RECORD OF DECISION  
INTERIM REMEDIAL ACTION  
BUILDING 103 DUMP, OPERABLE UNIT 1  
EDGEWOOD AREA-ABERDEEN PROVING GROUND, MARYLAND

**RECORD OF DECISION**

**BUILDING 103 DUMP**

**U.S. ARMY, EDGEWOOD AREA-ABERDEEN PROVING GROUND, MARYLAND**

**Figure 3** Typical Cross Section for Alternative 6 (RCRA Cap Using Sodium Bentonite Geocomposite Mat and Synthetic Membrane)

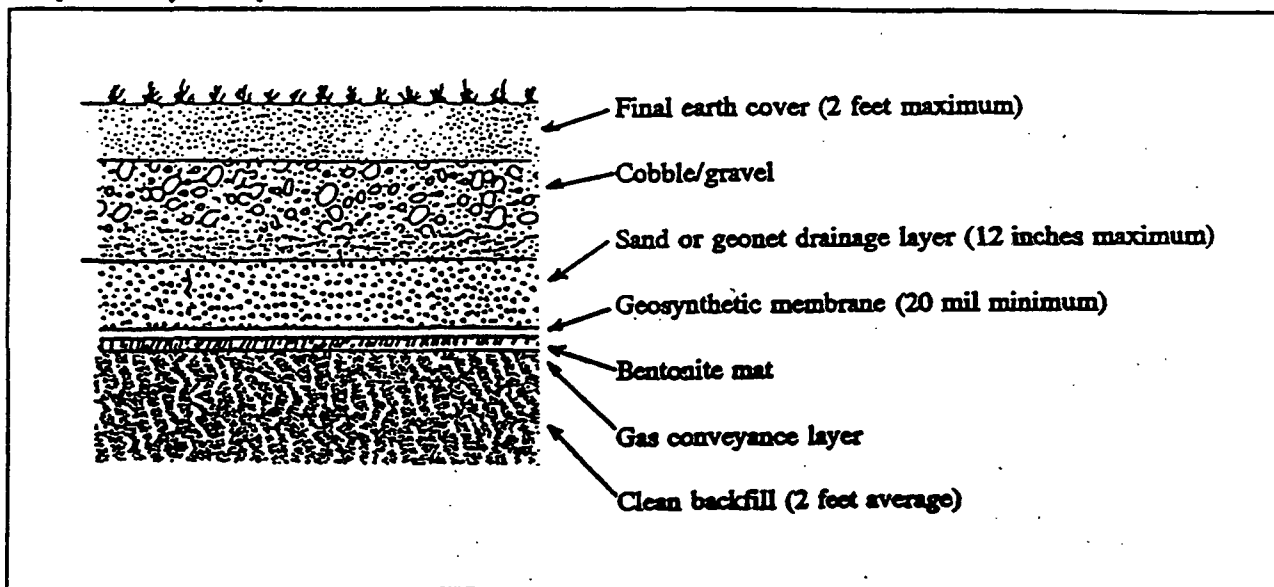
APGSCC has a variety of concerns regarding cap construction. A major concern for APGSCC, as well as the Army, is contaminant migration. The Building 103 landfill cap will have a three-foot gravel and cobble layer, a two-foot compacted soil layer, a one-foot layer of sand and will be covered by a two-foot layer of compacted soil. This cap construction will add many tons of weight to the site and will exert a downward pressure. It is known that the water table aquifer is extremely close to the surface and already contaminated. APGSCC is concerned that the hydrostatic pressure caused by such a cap may push the contaminated water downward and radially outward, thereby expanding the area of contamination and displacing any interstitial gas. Since reducing contaminant migration is the goal of building a cap, we believe this possibility of increasing contaminant migration must be addressed before deciding whether placing a cap on the site is the best action.

The cap and cover system cross section presented in the Proposed Plan was a preliminary cross section design concept aimed at minimizing the infiltration of water into the waste. However, during the 30 percent design phase, the design will be refined with the added criteria of minimizing the thickness of the cap and cover system. This is necessary because of the proximity of Williams road and Hoadley road, and adjacent buildings. The cross section to be presented in the 30 percent design will have all the layers of the conceptual design presented in the Proposed Plan, but will be thinner and lighter than the concept presented in the Proposed Plan. The effect of such the cap and cover system on the hydrostatic pressure has already been investigated. Preliminary settlement calculations performed show that the total settlement of the existing cover will be approximately 0.25 inches. Therefore, there is little likelihood that the additional load of the cap and cover system to be constructed will expand the areal and vertical extent of contamination and displace any interstitial gas. If the waste compresses 0.25 inches, there should be a negligible effect on the hydrostatic pressure in the surficial aquifer.
